SERVICE LETTER 248

Water Deflection Panel (Bulkhead #17) Reinforcement

Aircraft Makes/Model(s):	Float Model(s):	Compliance: Optional	By: MAS
Air Tractor AT-802 and AT-802A	10000A	Part Number: 1012082	Approved: SDW
		Date: 6/15/2022	Revision: B

Figure 1

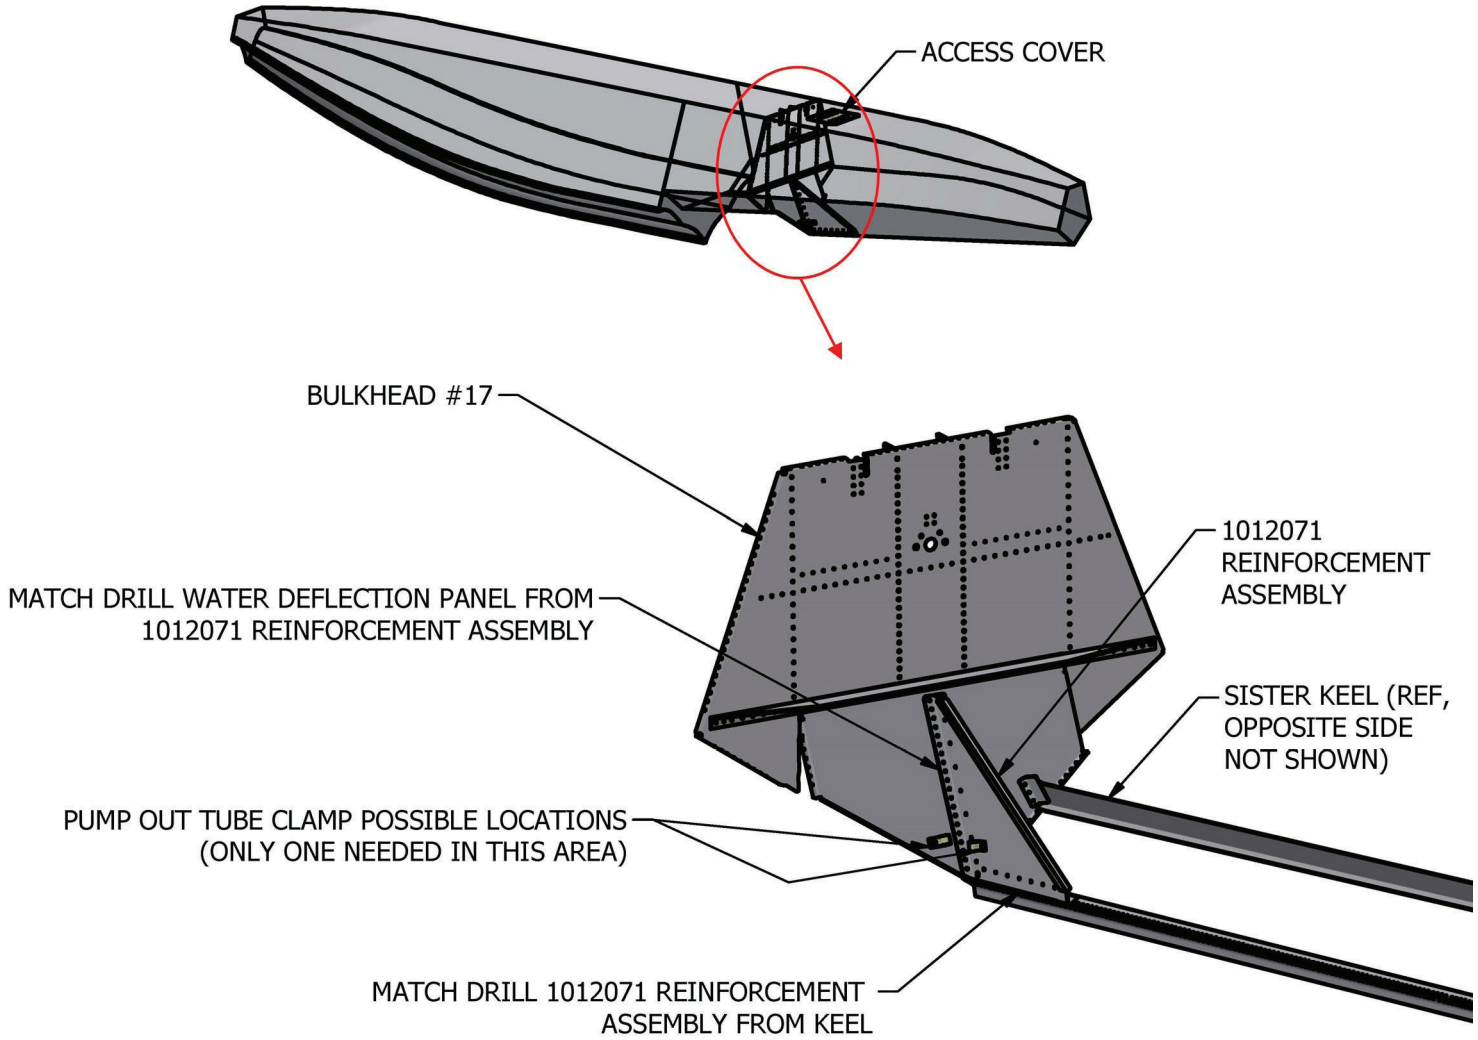
1. Position and prepare aircraft for safe maintenance.
 2. Remove top deck cover to gain access to bulkhead #17. See Figure 1.
 3. Remove pump-out tube from bottom of float bay. Remove tube clip and plug rivet holes if clip conflicts with reinforcement assembly (if within ~1" of bulkhead centerline).

4. Remove rivets from keel between the flanges of bulkheads #17 and #18.
 5. Remove sealant in the area as required.
 6. Match drill holes from keel into reinforcement assembly 1012071.

- Note:** If the forward-most or aft-most keel rivet locations between the bulkhead flanges would violate 2D edge distance (ref: AC 43.13-1B) if placed in the reinforcement assembly, it is acceptable to trim the reinforcement assembly flanges to clear these rivets. Maintain the necessary edge distance for the adjacent rivet locations.

7. Match drill the vertical holes from reinforcement assembly into bulkhead #17.
 8. Remove parts and debur all new holes.
 9. If the pump-out clip was removed in step 3, it may be relocated to the reinforcement assembly at this time, if desired.

10. Install assembled pieces using PR-1422 (or equivalent) at contacting surfaces and MS20470AD5 rivets.
 11. Edge seal the installed reinforcement assembly and prime as needed.

12. If removed in step 3 and not already relocated in step 9, relocate the pump-out tube clip. The clip may be located on the new reinforcement parts or on bulkhead #17 (as before). Install the pump-out tube.
